**Invitation to Bid
Welding Building Remodel
35-2015/2016**

PENSACOLA
STATE COLLEGE

Addendum #1

SHEET:
T-100

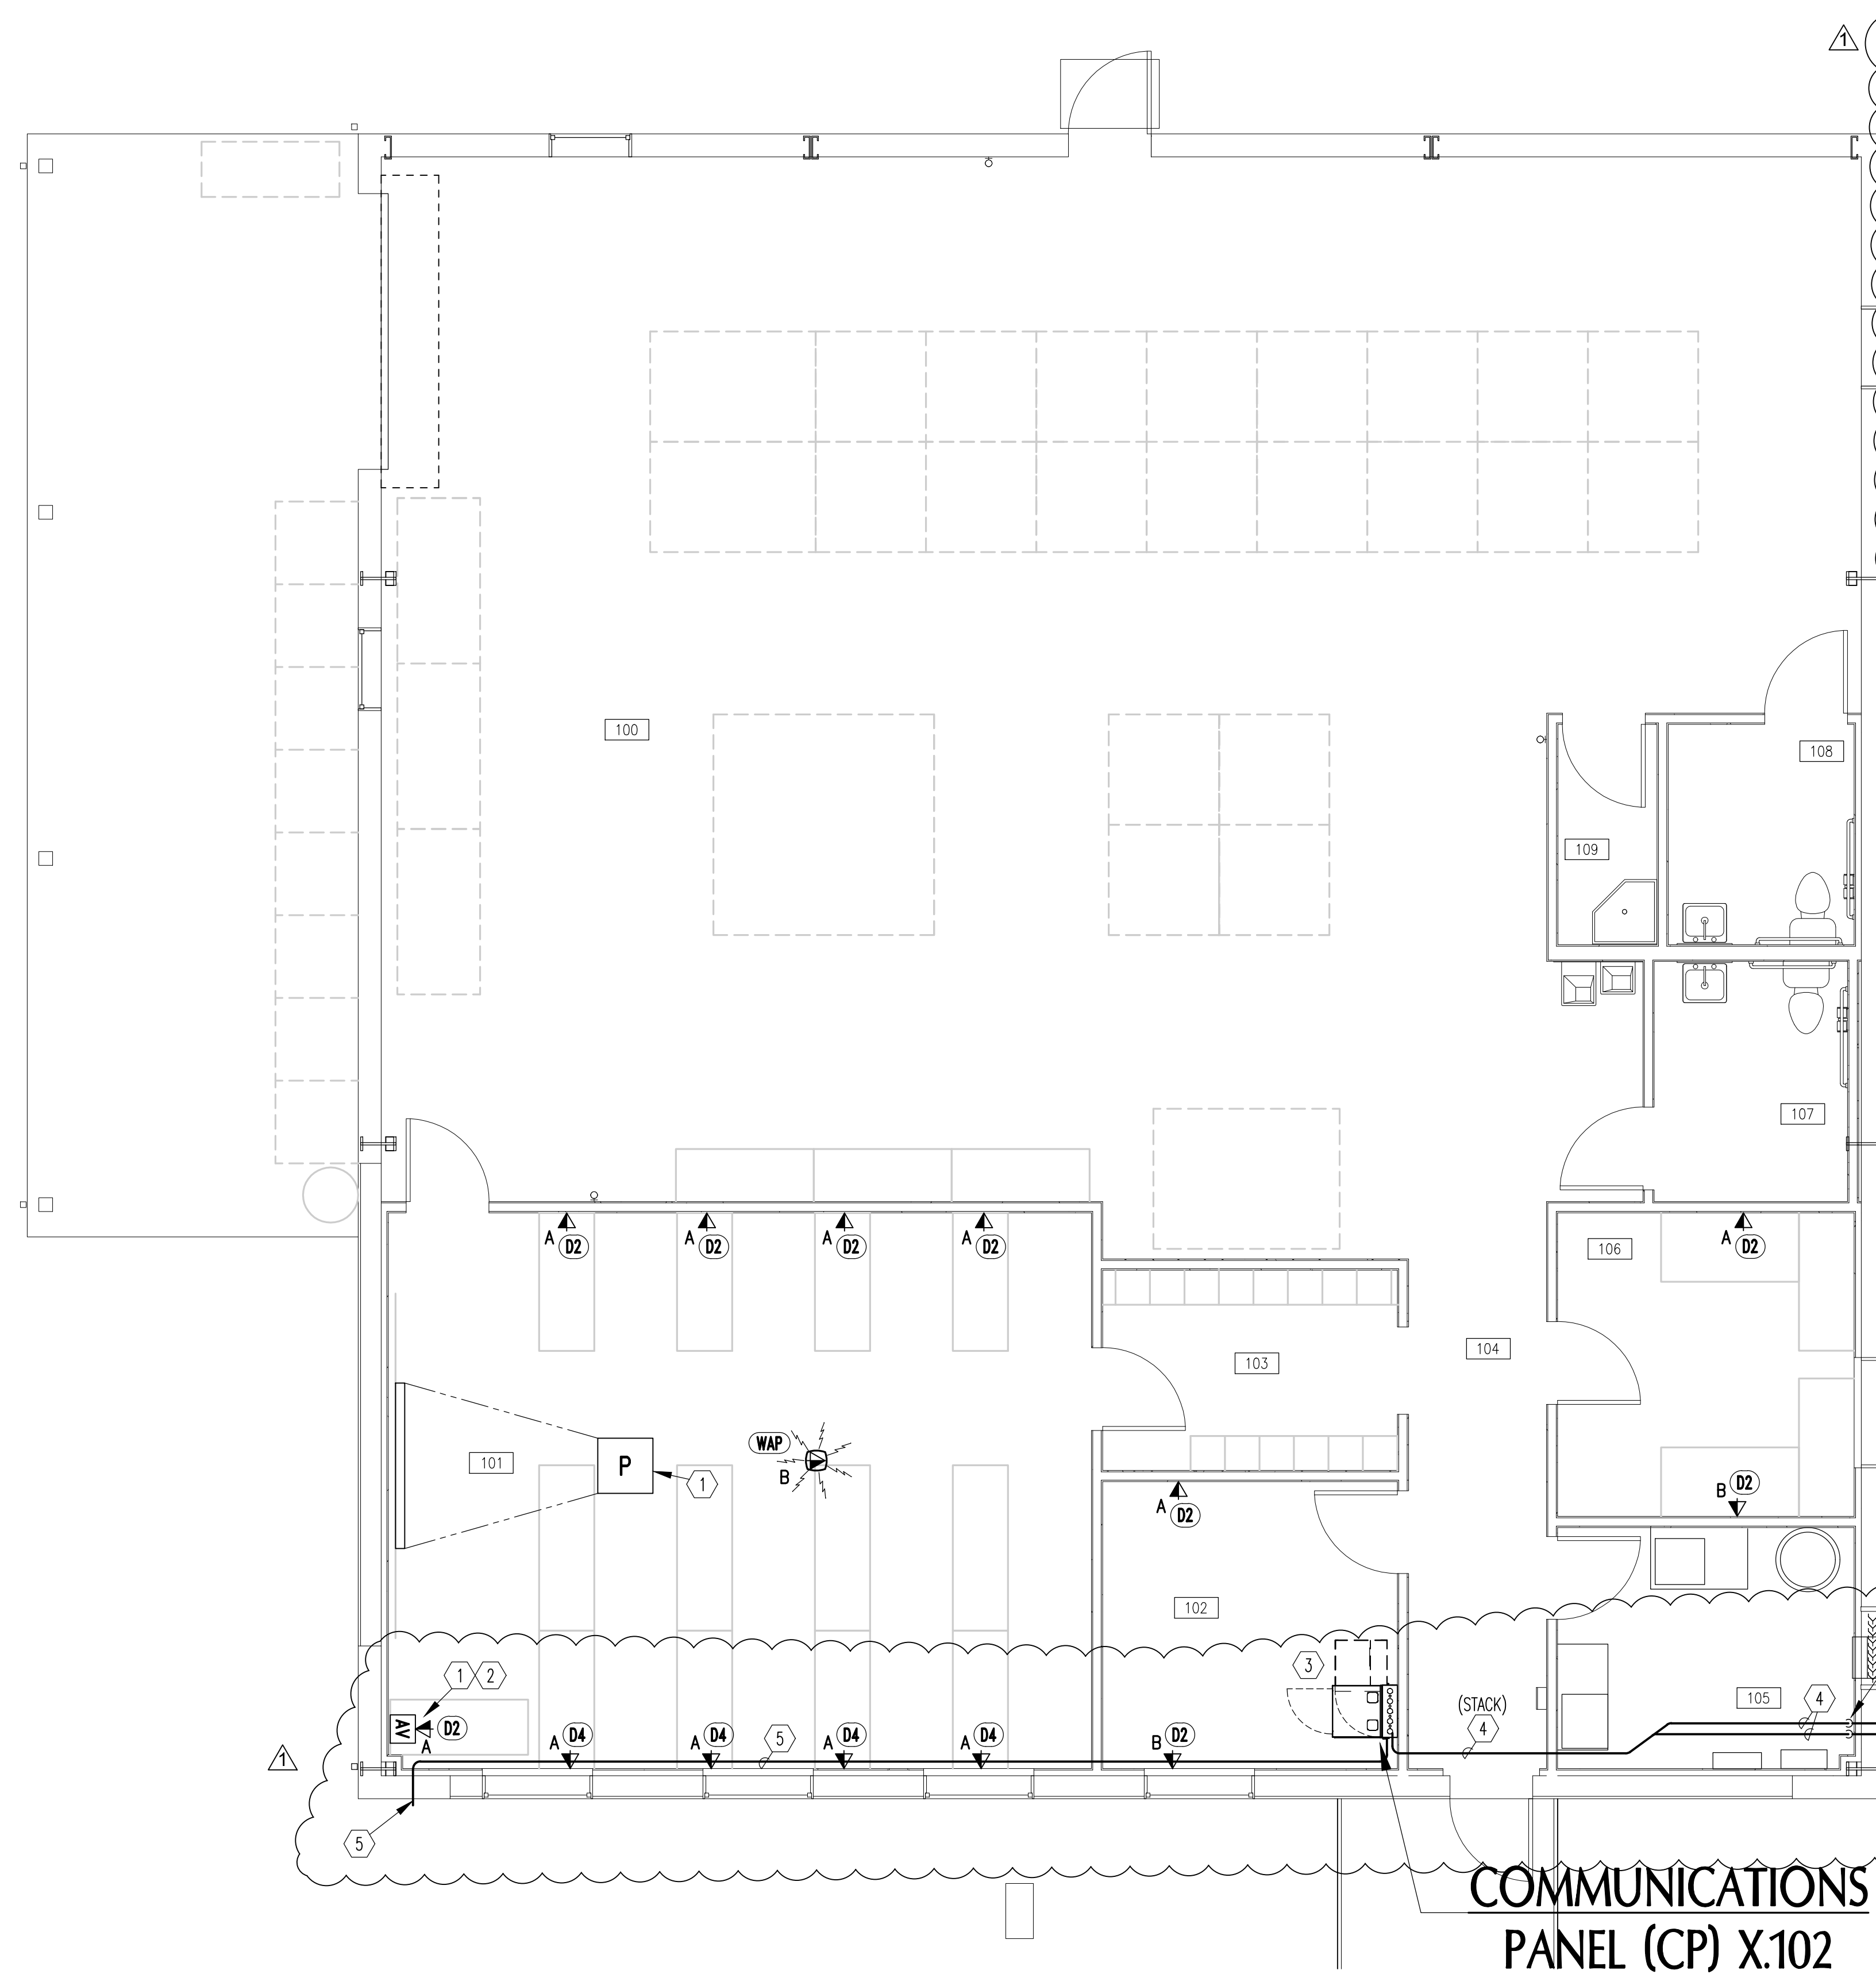
Question: The CP details call for a fiber optic patch panel but the Single line diagram shows a Cat 6 cable tie-in to the existing service. Where does the Cat 6 tie cable tie-in to the existing service?
Response: See revised sheets. Service tie-in was previously unknown.
